**Harper Canyon (Encina Hills) Subdivision Project
Final Supplemental
Environmental Impact Report
SCH# 2003071157
PLN 000696**

December 2024

County of Monterey
2441 Schilling Place
Salinas, California 93901

Denise Duffy & Associates, Inc.
947 Cass Street, Suite 5
Monterey, California 93940

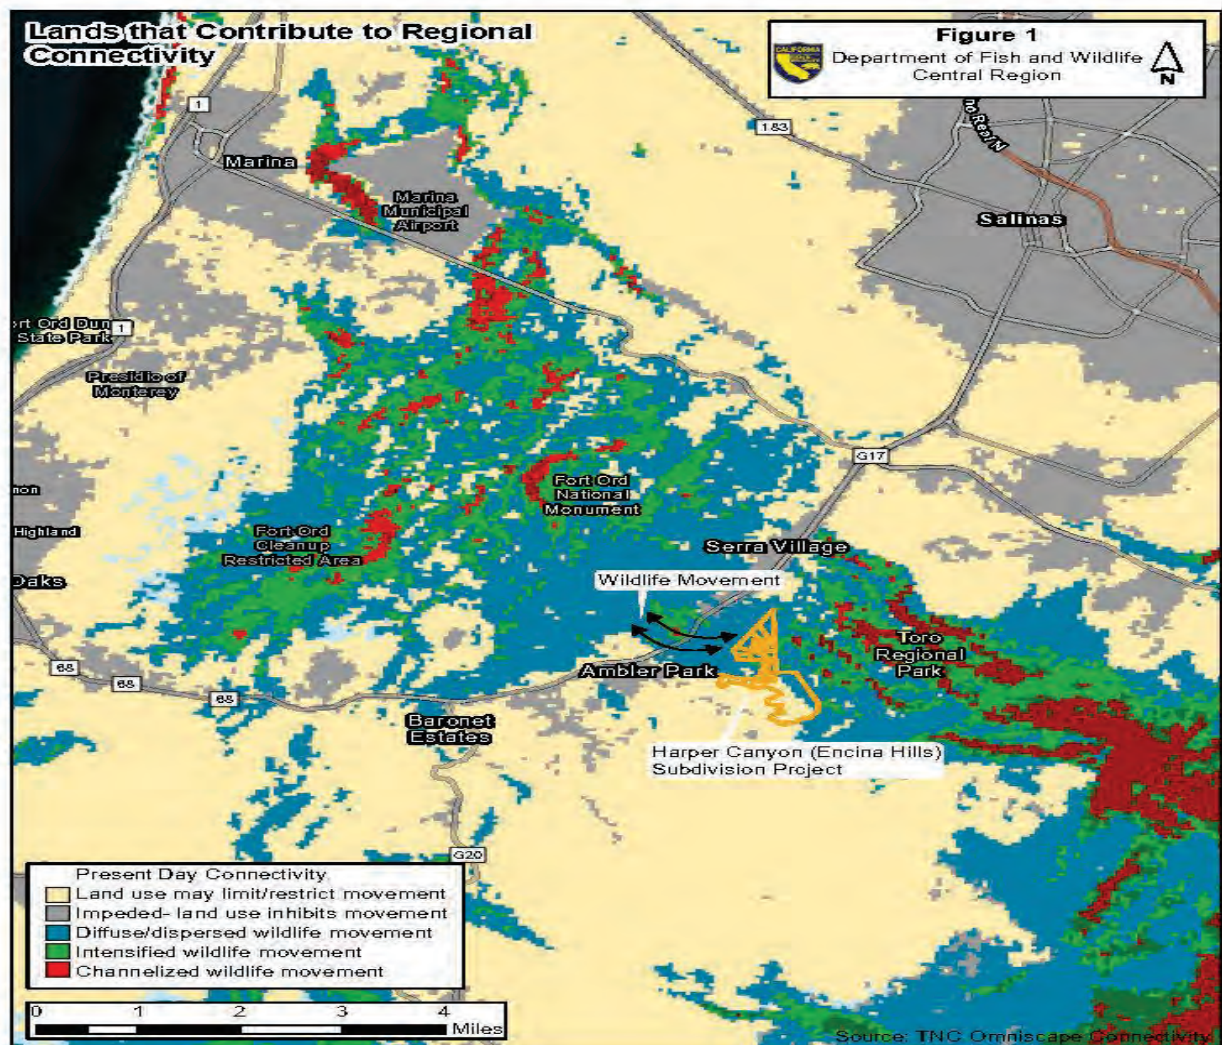
The Project's 17-lot residential subdivision would almost entirely block a primary wildlife corridor between Fort Ord and Toro Park and further isolate Fort Ord and the wildlife species that inhabit the monument (Attachment 1, Figure 1). Attachment 1, Figures 1 and 2, utilize The Nature Conservancy (TNC) Omniscape Connectivity Web Map (TNC 2024) dataset to model wildlife movement within and surrounding the Project site. As Attachment 1, Figures 1 and 2, depict, the majority of the residential subdivision is directly within the sole migratory pathway between Fort Ord and Toro Park. While the SDEIR recognizes the potential impacts to wildlife connectivity associated with the siting of the Project site, and specifically provides mitigation measures to protect a portion of the El Toro Creek corridor, CDFW is concerned that without the protection of the surrounding movement pathways identified in Attachment 1, Figures 1 and 2, the Project would not adequately mitigate for the impacts to wildlife movement.

As the proposed Project is likely to significantly restrict wildlife movement between Fort Ord and Toro Park, CDFW recommends the SDEIR be revised and that the Project site be redesigned to allow for a minimum 1.2-mile-wide corridor through the movement areas identified in Attachment 1, Figures 1 and 2 that are within the Project site, to maintain the linkage between Fort Ord and Toro Park. This corridor width recommendation follows the recommendations noted in the South Coast Missing Linkages Project (Penrod et al., 2006), a project focused on finding missing linkages, or corridors, in southern California, which notes that a minimum 1.2 miles width allows, “For a variety of species [...] a wide linkage helps ensure availability of appropriate habitat, host plants (e.g., for butterflies), pollinators, and areas with low predation risk.

The comment acknowledges that the mitigation measures identified in the SDEIR protect a portion of the El Toro Creek corridor. However, the comment expresses concern that without protection of the surrounding movement pathways (identified in Figures 1 and 2 of the attachment to Letter E), that project would not adequately mitigate for the impacts to wildlife movement. As stated in this response, the proposed project would provide additional

protection of the surrounding movement pathways by maintaining a 180-acre open space parcel, donating 154 acres of that parcel to expand Toro County Park. Portions of this parcel fall within the diffused/dispersed movement areas, which are those categorized by The Nature Conservancy as areas with high flow (e.g., areas of open space with limited human modification). It should be noted that the other surrounding movement pathways identified as diffused/dispersed movement areas in Figures 1 and 2 include the Fort Ord National Monument, Toro County Park, and Marks Ranch, which are currently protected as open space. Lastly, as a mitigation requirement, corridors through the project site will be identified in the final map where no development shall occur.
